**RE: ROADSTONE WOOD LIMITED : WASTE LICENCE APPLICATION W0269-01  
FASSAROE WASTE RECOVERY FACILITY  
RESPONSE TO SECTION 16 REQUEST FOR FURTHER INFORMATION**

**INERT WASTE RECOVERY FACILITY  
FASSAROE, BRAY, CO. WICKLOW  
(Ref. No. W0269-01)**

**WATER MANAGEMENT PLAN  
(Response to EPA Letter dated 7 October 2010)**

FIGURE RFI 2

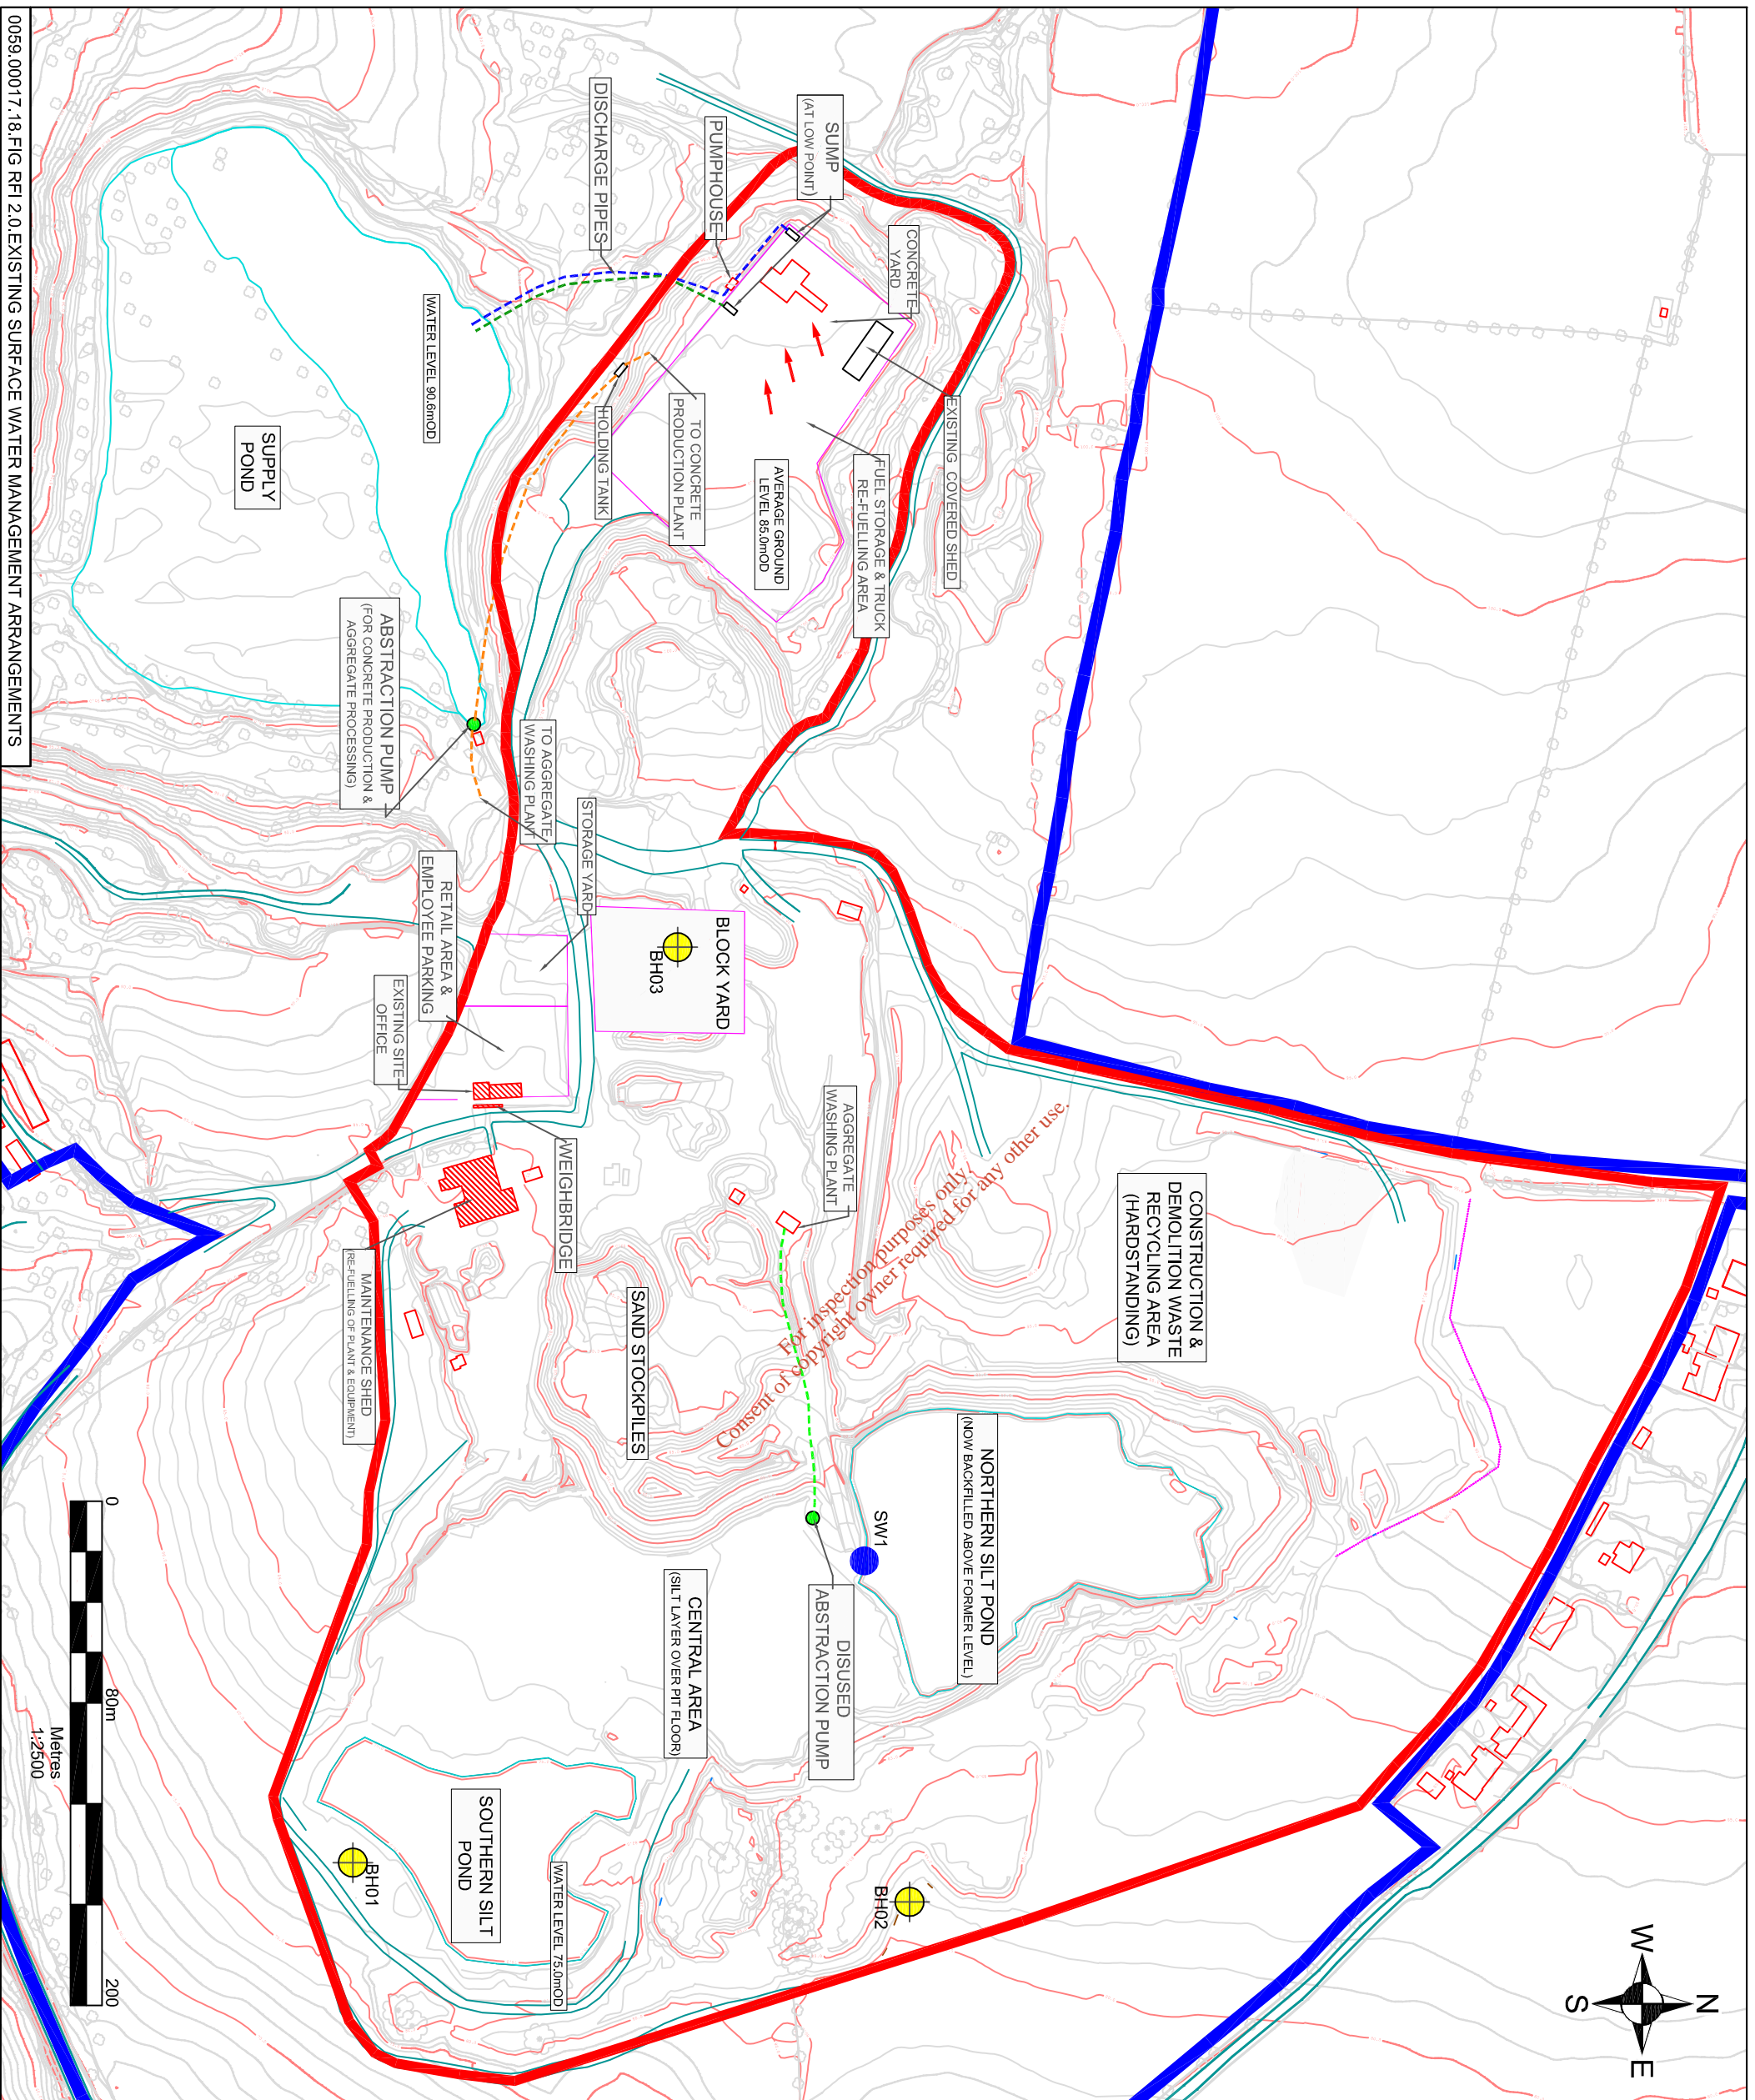
At the time the waste licence application was submitted, consideration was given to possible construction of modest scale temporary infiltration / intermediate settlement ponds on the undisturbed ground immediately south-east of the sand washing plant to provide for discharge of water from the southern silt pond to groundwater (refer to Figure RFI2).

For this reason, it is not now envisaged that any temporary infiltration / intermediate settlement ponds will be constructed to provide for discharge of water from the southern silt pond to groundwater or reduce concentration of suspended solids in pumped water. It is now envisaged that all water in the southern silt pond will be pumped directly to the supply pond.

**FIGURE 2-11**

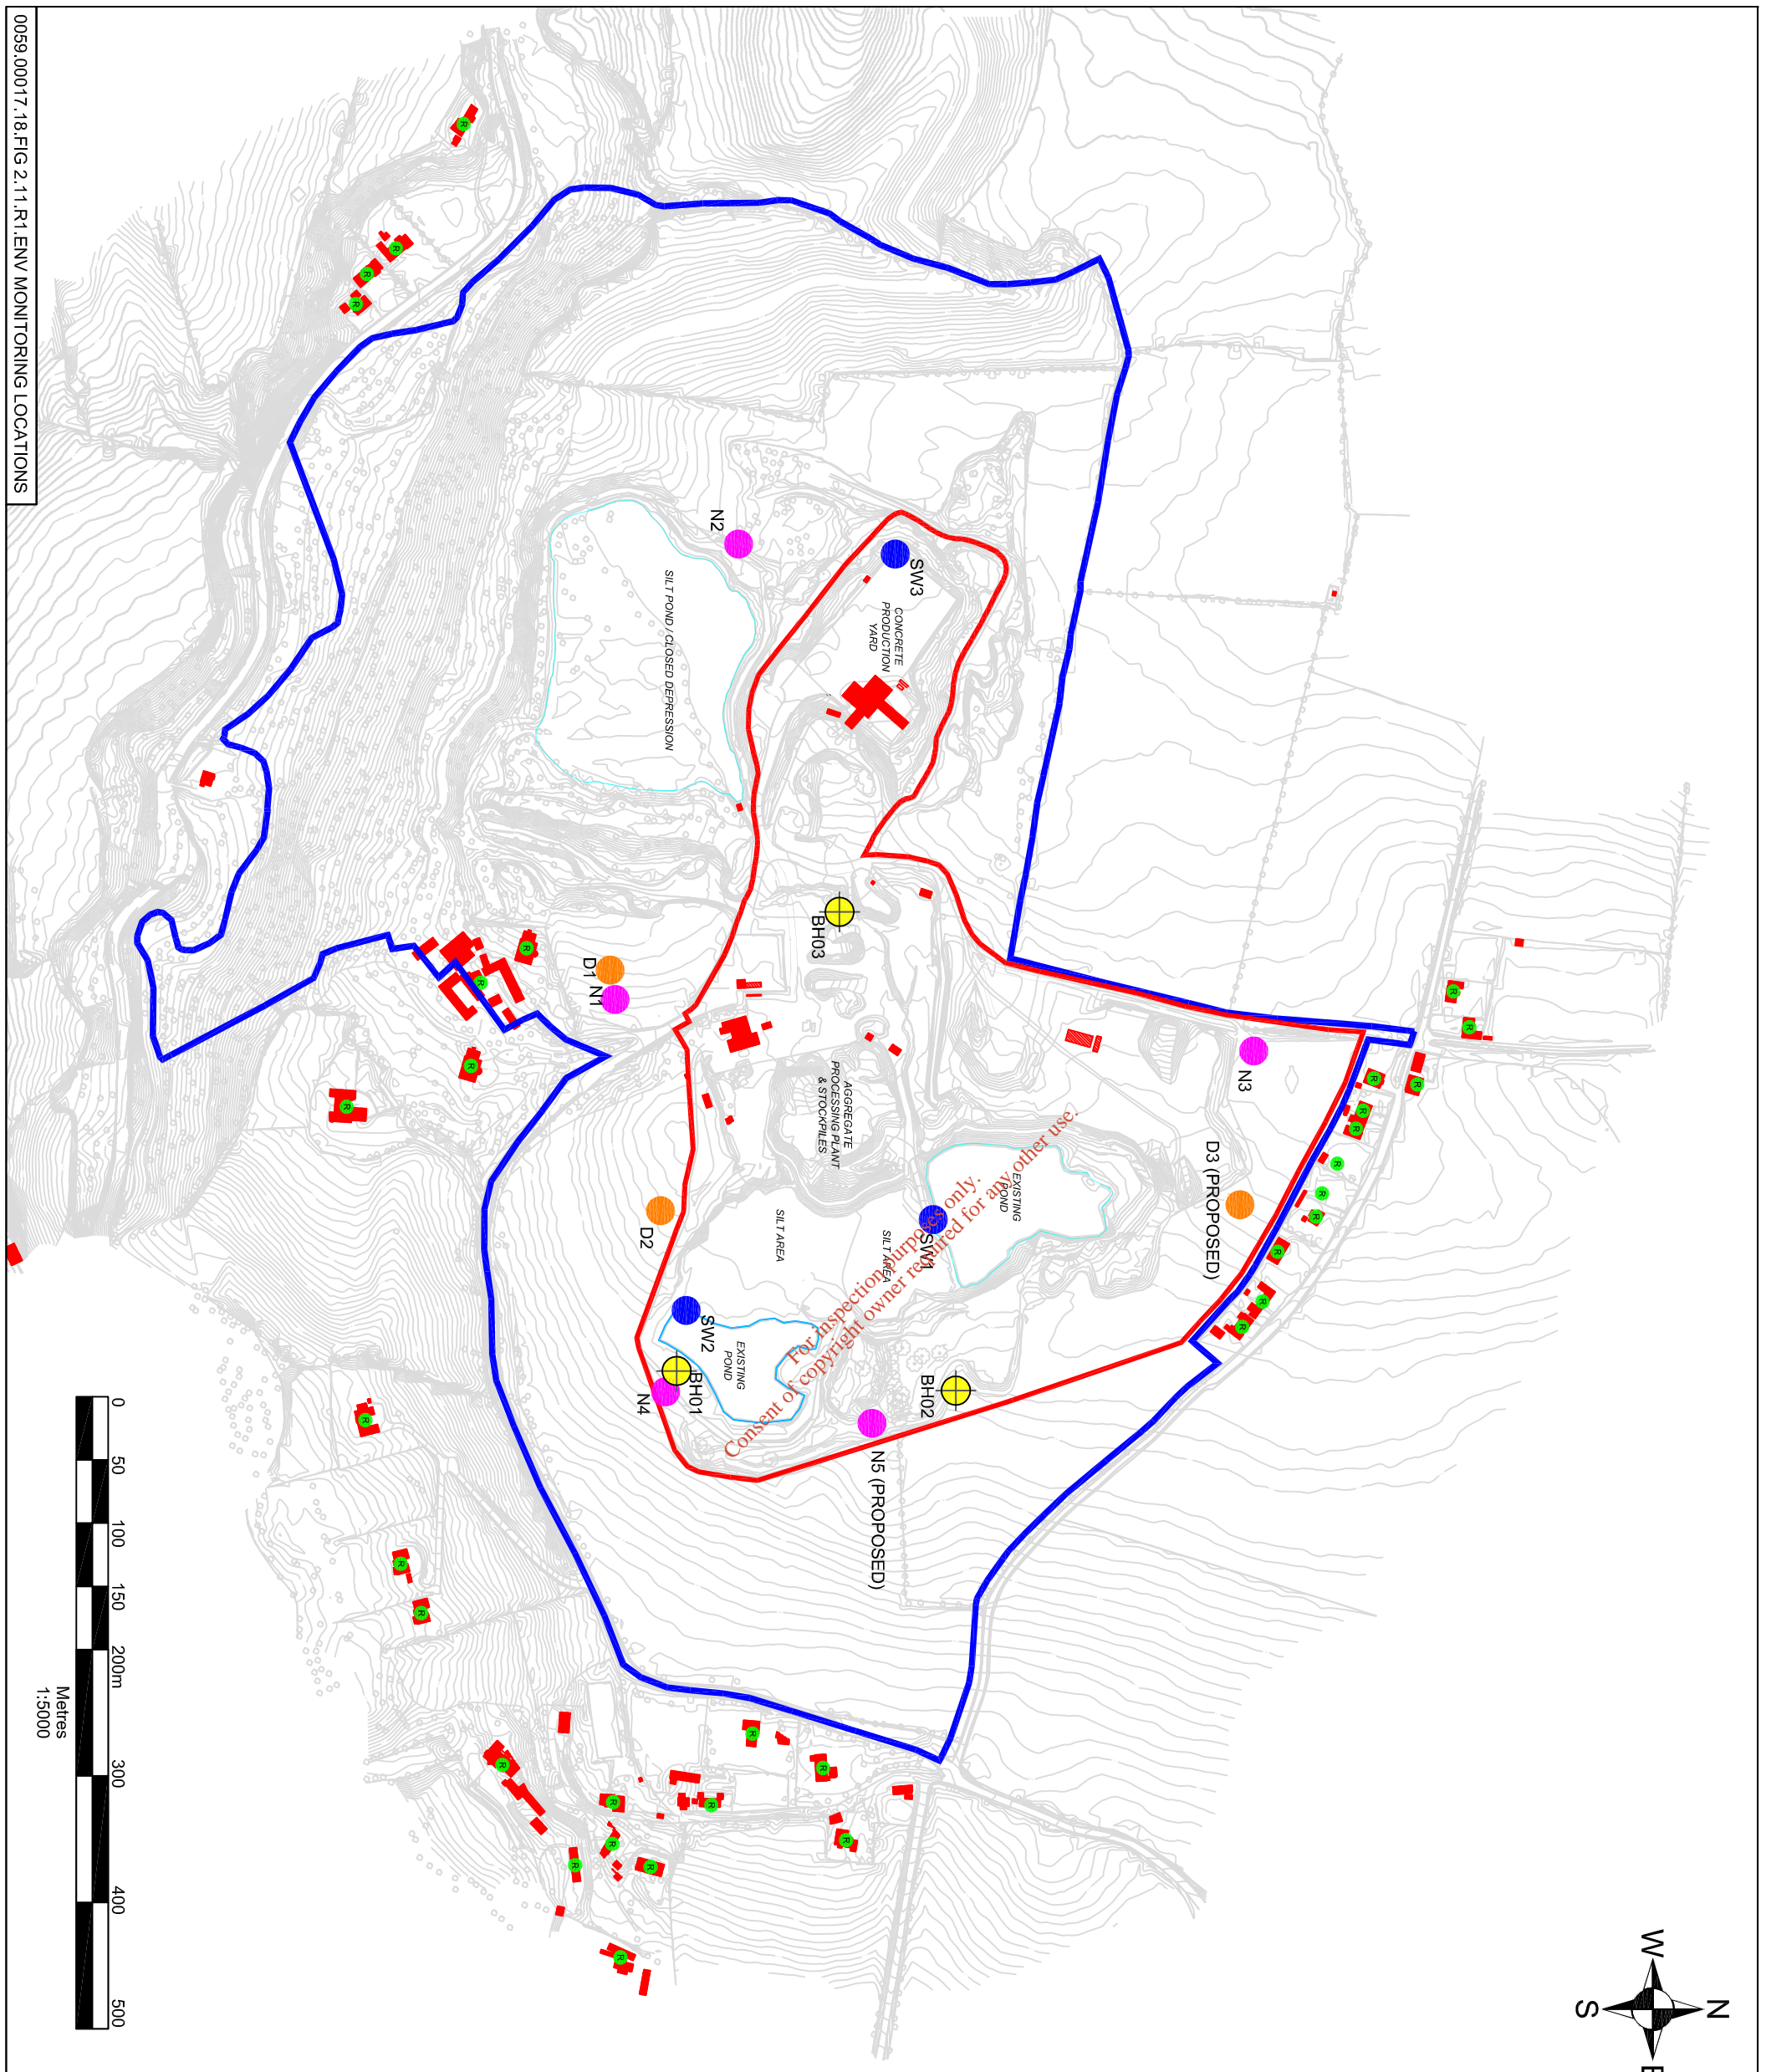
It is envisaged that surface water sampling and testing will be undertaken by external consultants on a bi-annual basis (i.e. six monthly) basis at the **northern and southern (SW1 and SW2)** pond on the quarry floor. The **locations of proposed** surface water monitoring locations **are** indicated on Figure 2.11. **This includes monitoring of treated run-off on the downstream end of the proposed bypass interceptor to be installed in the south-western corner of the concrete production yard (SW3).**
